Product Change Notification

Product Group: SF/Fri Feb 23, 2024/PCN-SF-387-2024-REV-0

Sfernice-CH02016 & CHA02016 Backside color change

Sfernice-CH02016 & CHA02016 Backside color change

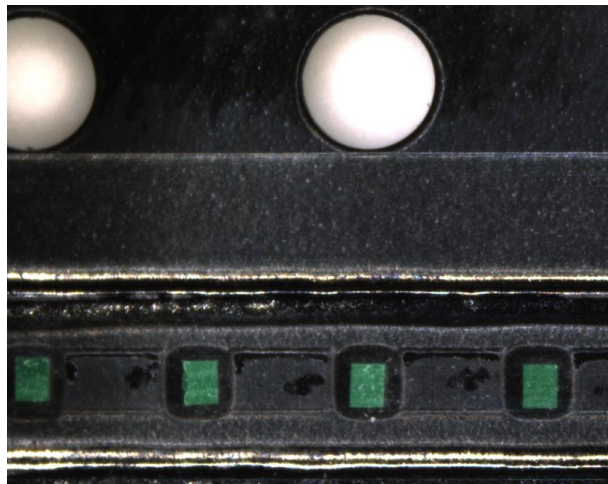
CH02016 with active face down in tape and reel (F or M termination) have back-side blue inked to indicate right orientation and facilitate the positioning in the Vishay tape and reel process.

- Before : Green color

- Today : Blue color
